AMENDMENTS TO THE DRAWINGS:

REMARKS

WO 2005/078843

PCT/GB2005/000355

Figure 4 - SOFC system operating on LPG showing method of implementation described in Method 1

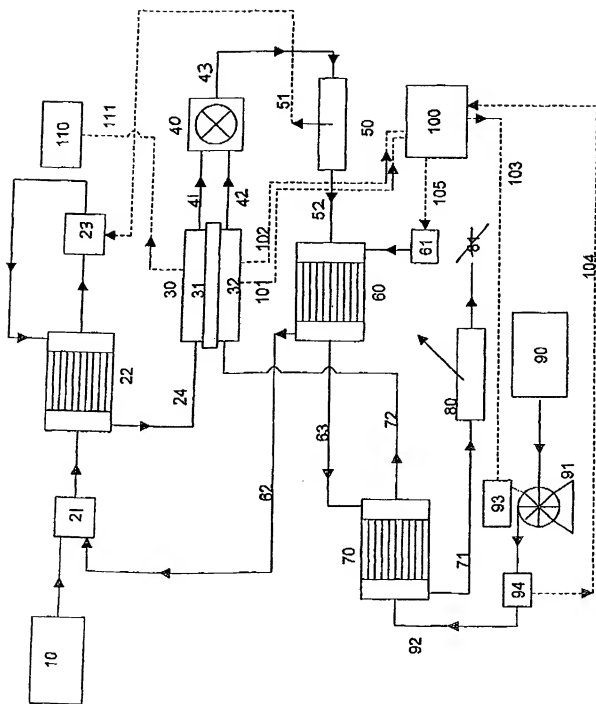
The specification has been amended to refer to reference number 92 in the description of Figure 4. Figure 4 has also been amended to delete reference number 81, which does not appear in the description. Figure 12 has been amended to correct an obvious error.
